**Re: Storm Water Inspection at New Residential Residence/Permit #4GC02482\*AG**

This letter is written in follow-up to a construction storm water inspection by Katie Anderson and Rachelle Howe, of the Ohio EPA, at the residence located at 9233 Hyland Croy Road in Union County on July 7, 2009. The purpose of the inspection was to ensure continued compliance with the General Storm Water Permit Associated with Construction Activities. During the inspection, we noted the following:

Figure 1: Area near house requiring protection from erosion

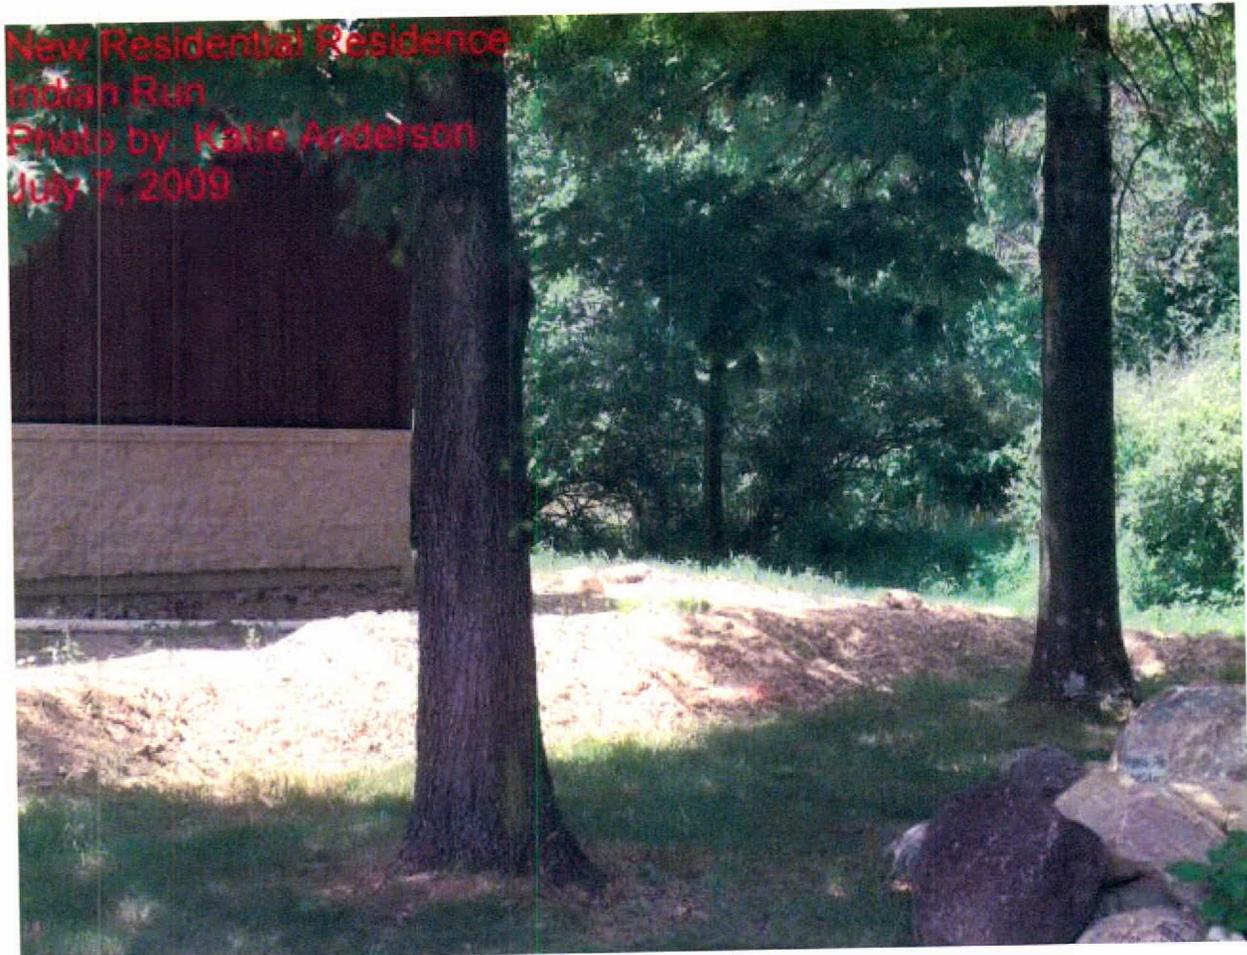
- The area around the house and near the pond must be stabilized to ensure appropriate protection from erosion (See Photo Figure 1). Be aware the General Permit states that all barren areas which remain idle in excess of 21 days must be protected from erosion within seven days of the last earth disturbing activities. In addition, erosion protection must be implemented for all areas of final grade within seven (7) days.
